### PUBLIC ADDRESS SYSTEM

10-A AMPLIFIER

EQUIPMENT BULLETIN AMPLIFIER, 10-A

- 1. Reason for Release
  - 1.1 To include instructions for modifying this amplifier for the use of 242-A Vacuum Tubes.
- 2. Associated Drawings and Photographs
  - 2.1 A80-126, Wiring Diagram
  - A80-127, Schematic
  - Photo #9001

Power Stage for use where Maximum Energy is Required  
No. 10-A Amplifier  
Arranged for either alternating or direct current in the filament.

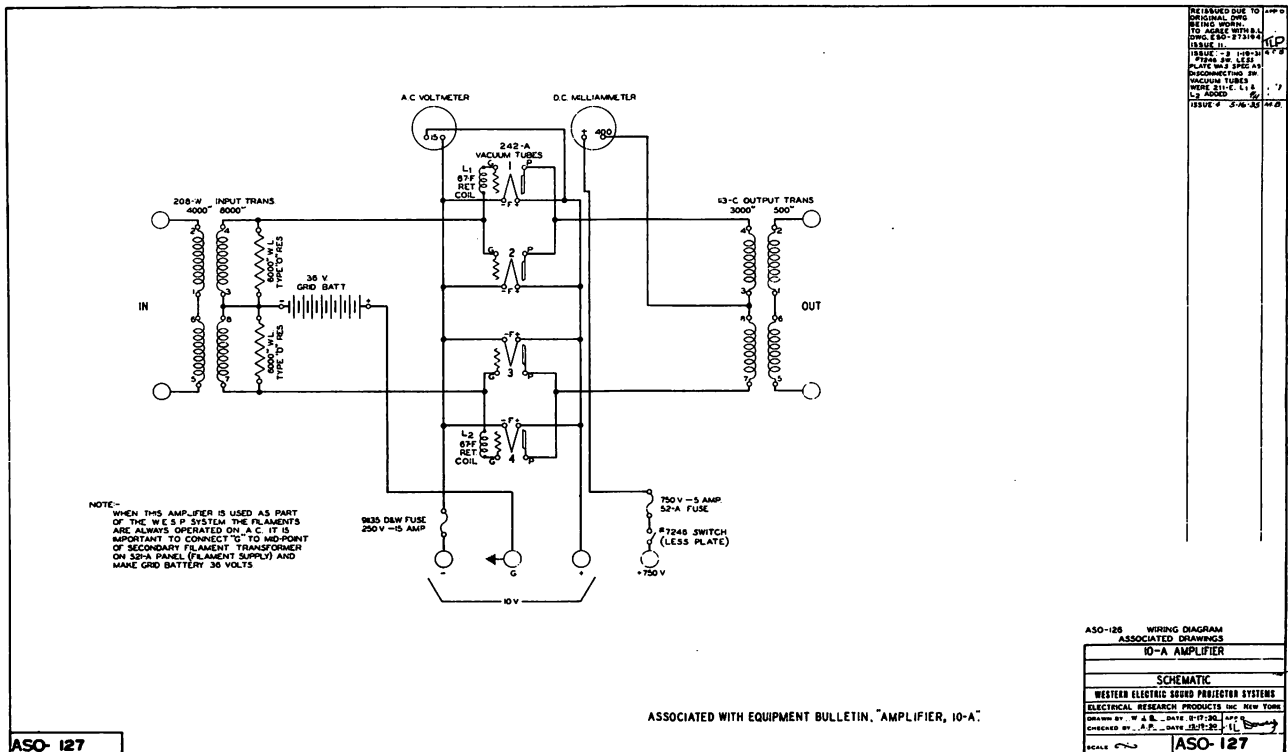
6000<sup>W</sup> input res. removed, imped. ratio of input transformer changed 4:1. Filament circuit changed to A.C.

Minor Changes.  
July 7, 1922  
ISSUE 3 HSH

FIG. 1

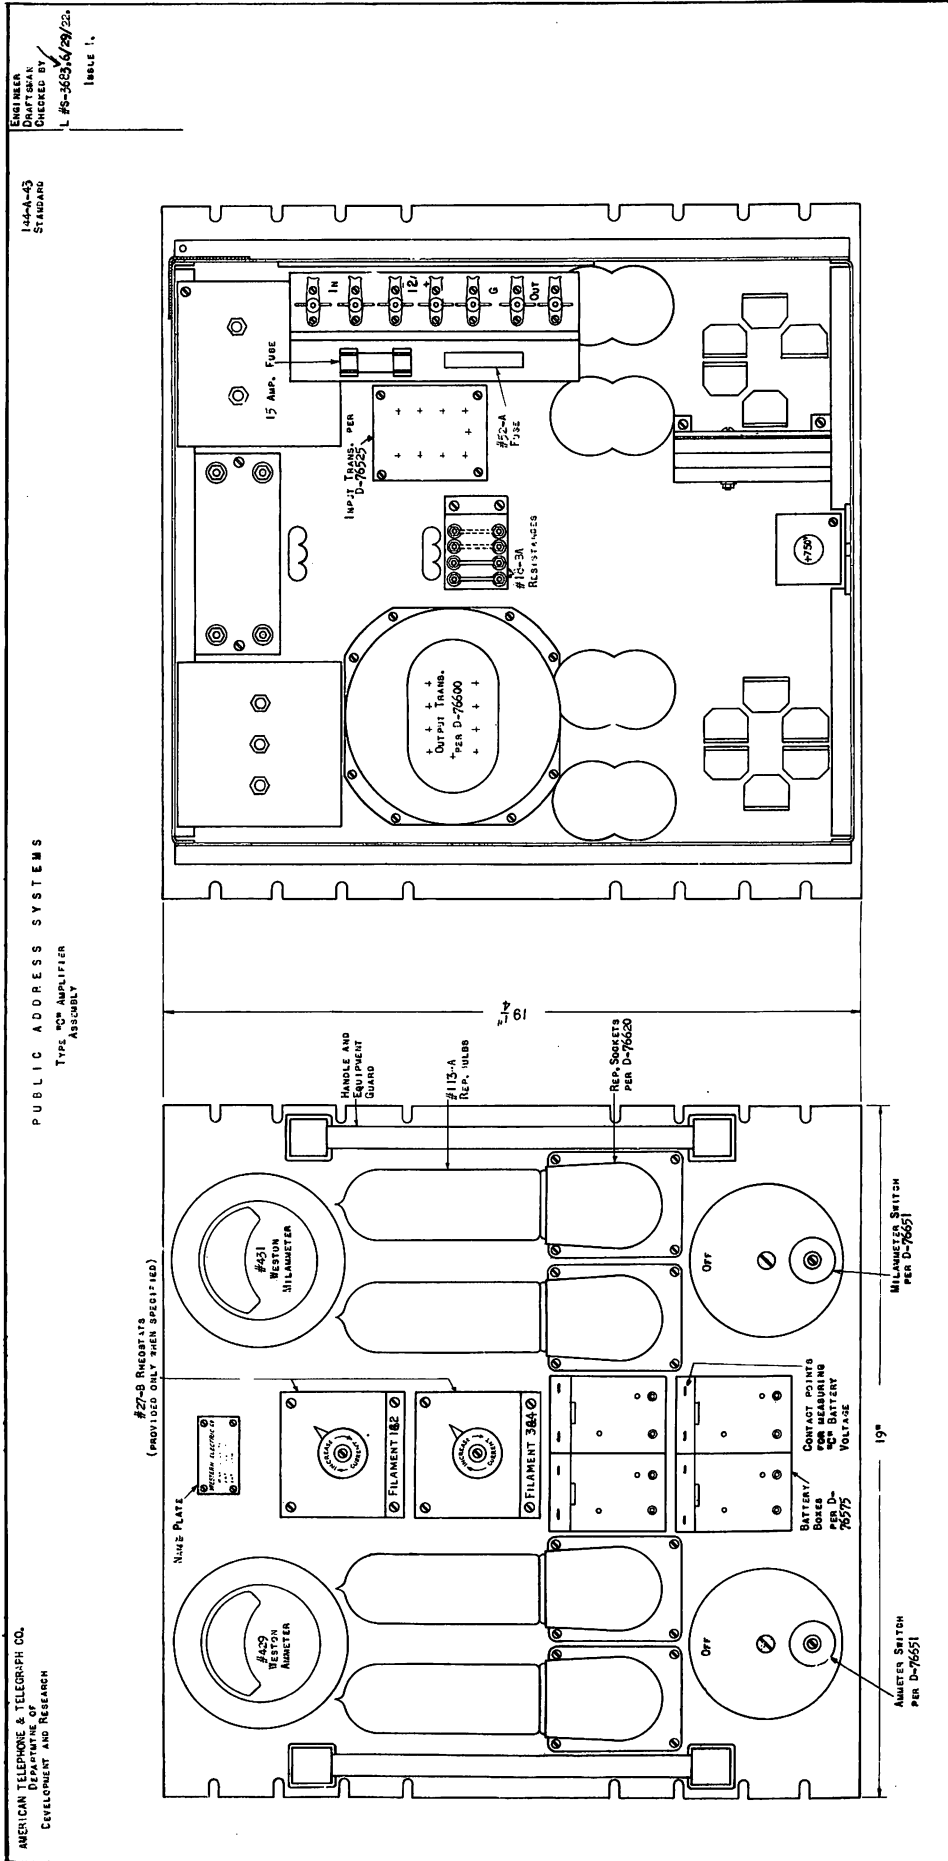
- (a) Disconnect all rear panel wires from the spring contact assembly terminals of the #6 type Battery Box, and detach the box.
- (b) Remove spring contacts from battery box by first cutting off the hooked ends of the terminals and then unsoldering the washers on the bottom side of the box.
- (c) Remove the small solder contacts (used when taking voltage measurements) embedded in the top side of the box, by means of a hot iron. This operation removes 10# of #13 contacts from the Battery Box.
- (d) Splice approximately 10# of #13 contacts (see Engineer's kit) to the end of each wire disconnected in operation from the terminals located in the amplifier panel, and pass these wires through the small insulating bushes in which the soldered contacts referred to in (c) were removed (see Fig. 1).

- (e) Remount battery box on amplifier panel.
- (f) Pull the motor lead wire extensions tight, and cut off leaving approximately 1/2" of slack for easy connection to the #781 Battery Terminals. Solder to the end of each wire (see Fig. 1), one of the special tinned locking terminal lugs supplied for this purpose (see Section 5.).
- (g) To the respective wires, attach tags marked as per Fig. 1.
- (h) Insert eight #781 Batteries into the box with their terminals outward and with the positive and negative posts of consecutive batteries adjacent to facilitate strapping together in series. Strap with bare lead copper wire of #18 or #19 Gauge, giving the wire one complete turn around each post, and drawing it tight by means of a pair of long nose pliers. Connect the new battery leads to their proper terminals. Finally, screw the binding post nuts down securely.

- (e) Remount the battery box on the amplifier panel.
- (f) Pull wires taut, leave 3/4" of slack; attach #2108 Locking Terminal (obtained from District Office); and tag per Fig. 1.
- (g) Insert #781 Batteries with terminals outward and opposite poles adjacent; strap with bare #18 Gauge wire, drawn taut, making one complete turn around each post; connect leads and tighten binding post nuts.
- (h) Amplifier recoding is not required.
